ADDENDUM NO. 1

Issued:	February 8, 2016	
Name of Bidder		
Receipt acknowle	dged by

To: Holders of Plans, Contract Documents and Specifications for White Park Trail – Phase II Federal Aid Project No. TAP-1102(705)

TYPICAL SECTIONS
WHITE PARK TRAIL PHASE II TAP-1102 (705)
AURORA, MISSOURI

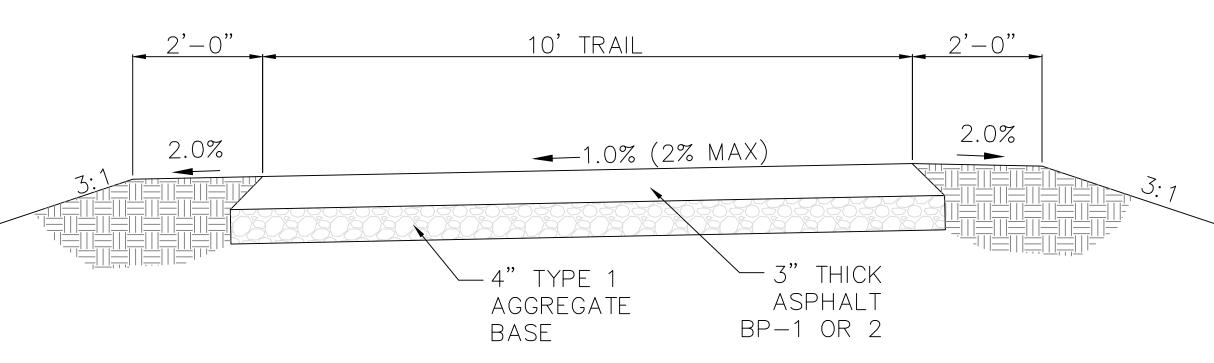
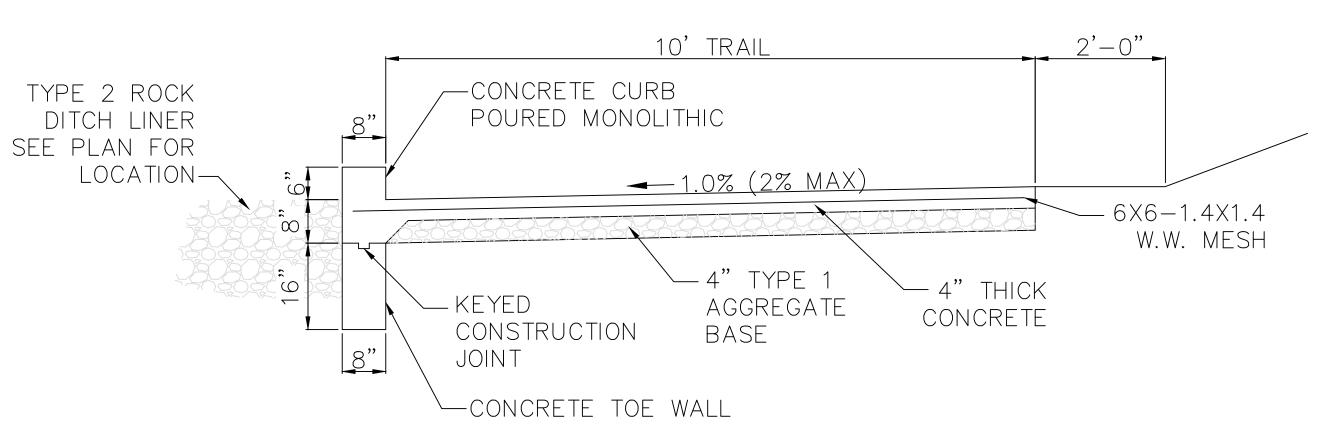
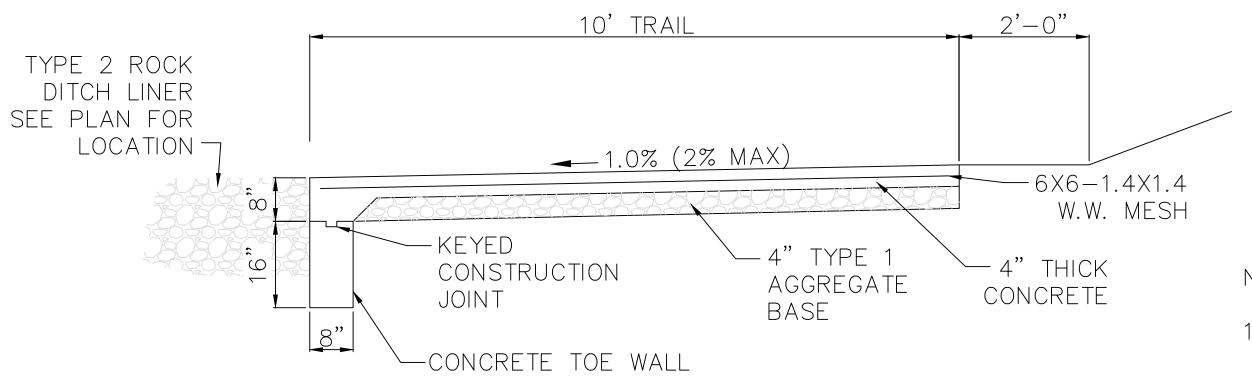
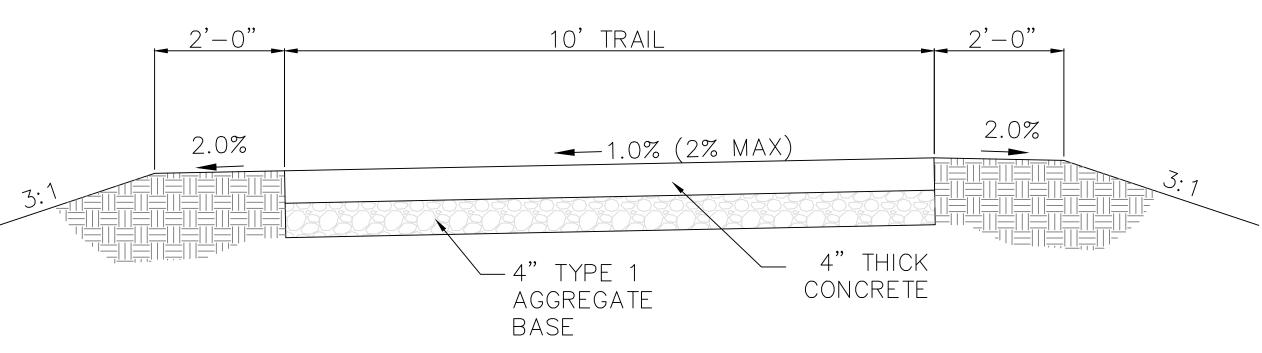
1. Drawings C1, C2, and C4 have been revised and are included herein. Bidders are instructed to remove drawings C1, C2, and C4 and replace with the attached. The stationing on the typical sections have been corrected and the corresponding quantities for concrete and asphalt paving have been updated.
